Appl. No. : **09/988,728**
Filed : **November 16, 2001**

REMARKS

Discussion of Drawing Changes

FIG. 2C

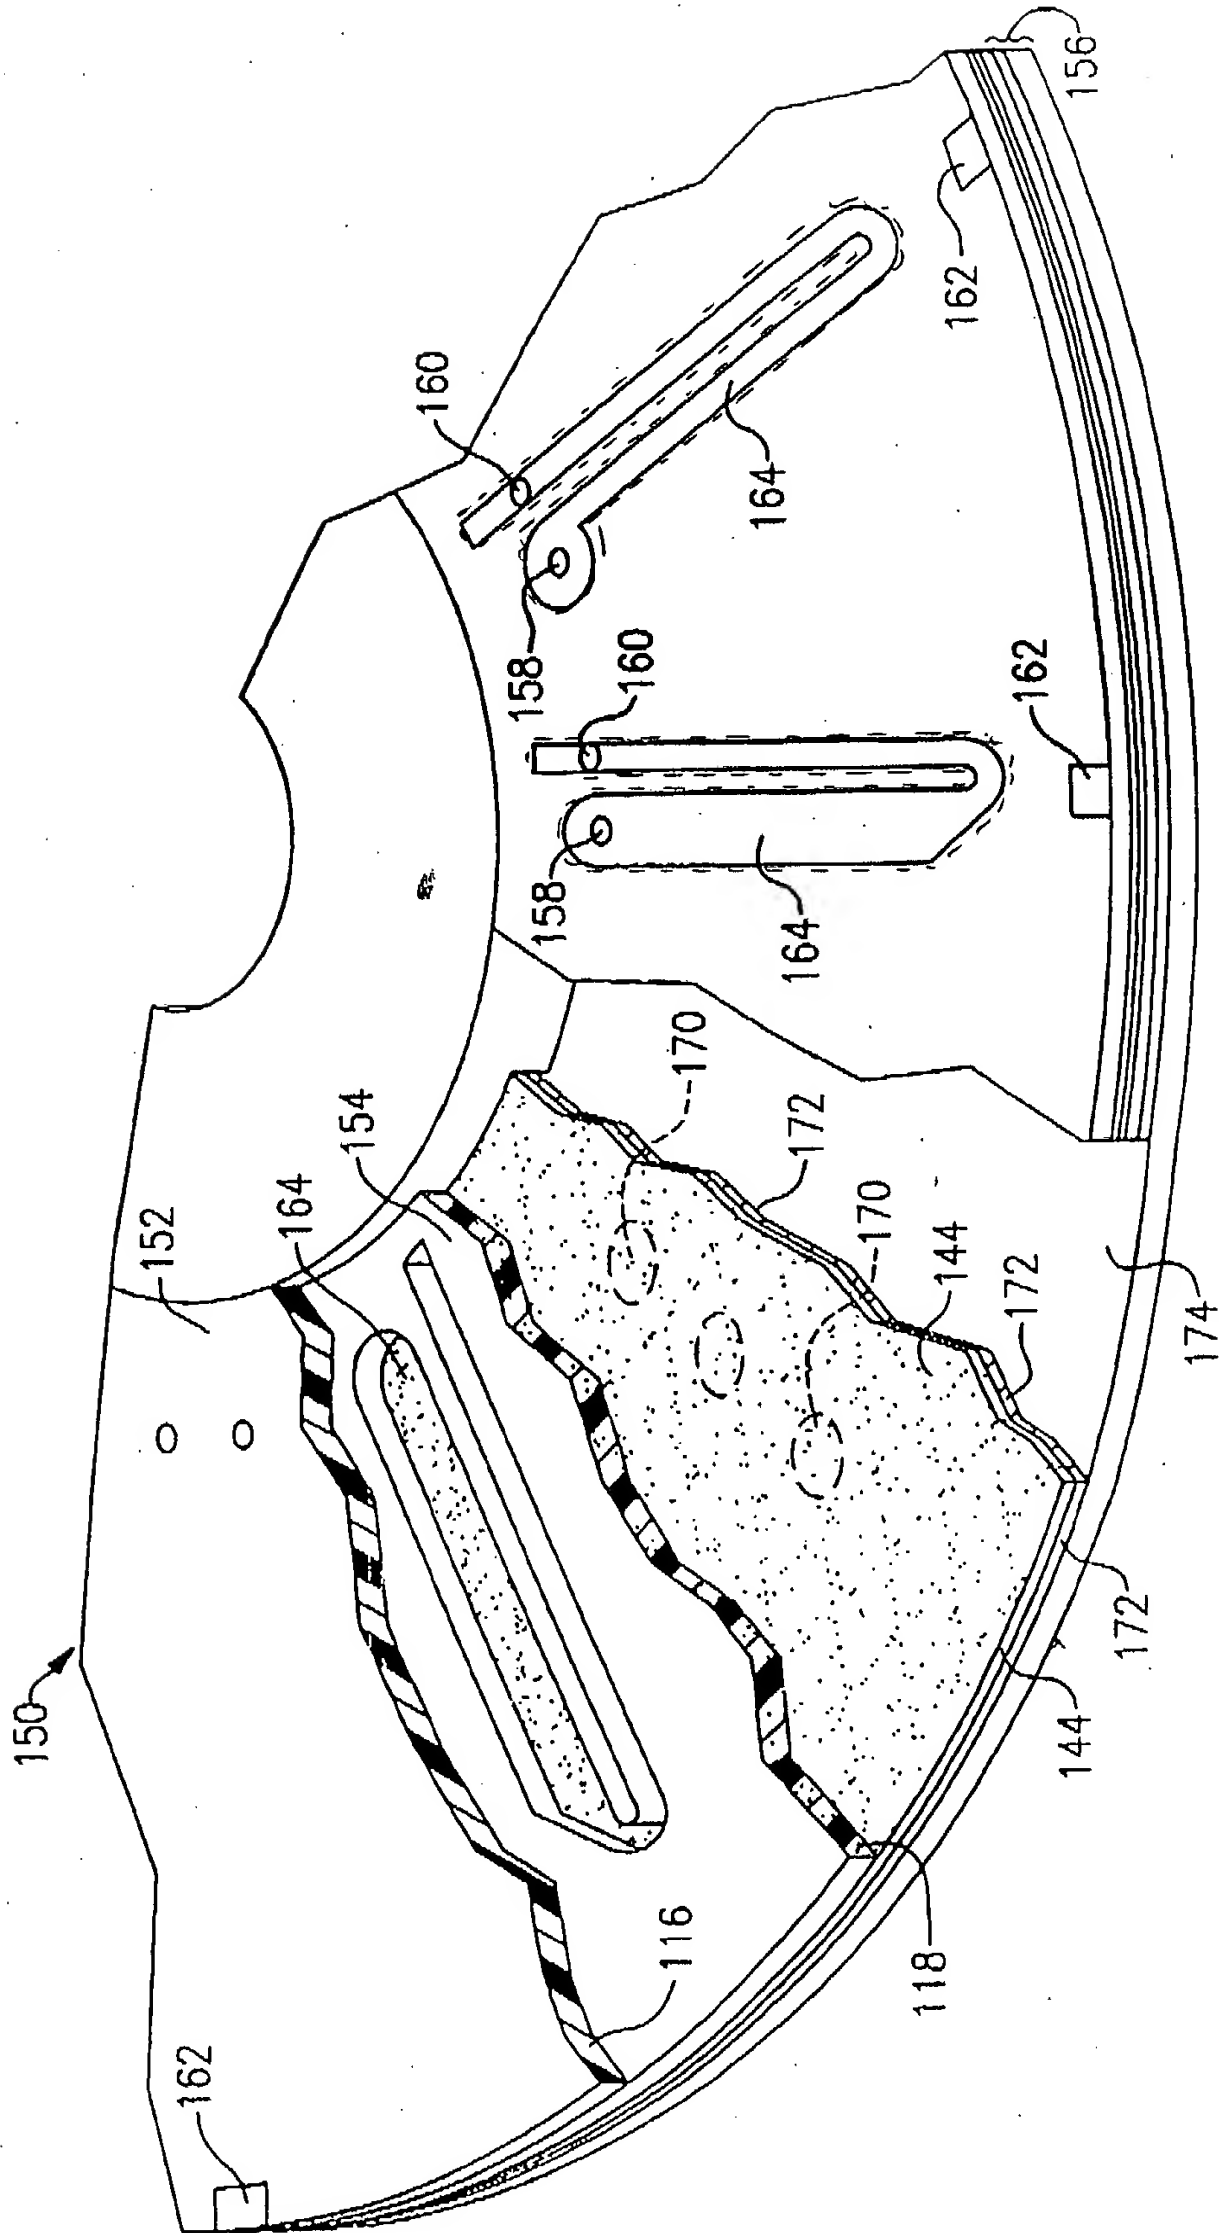
With respect to Figure 2C, the Examiner stated that the chambers 164 should not be visible on the right hand portion of the Figure. Applicant has amended the figure to correct this.
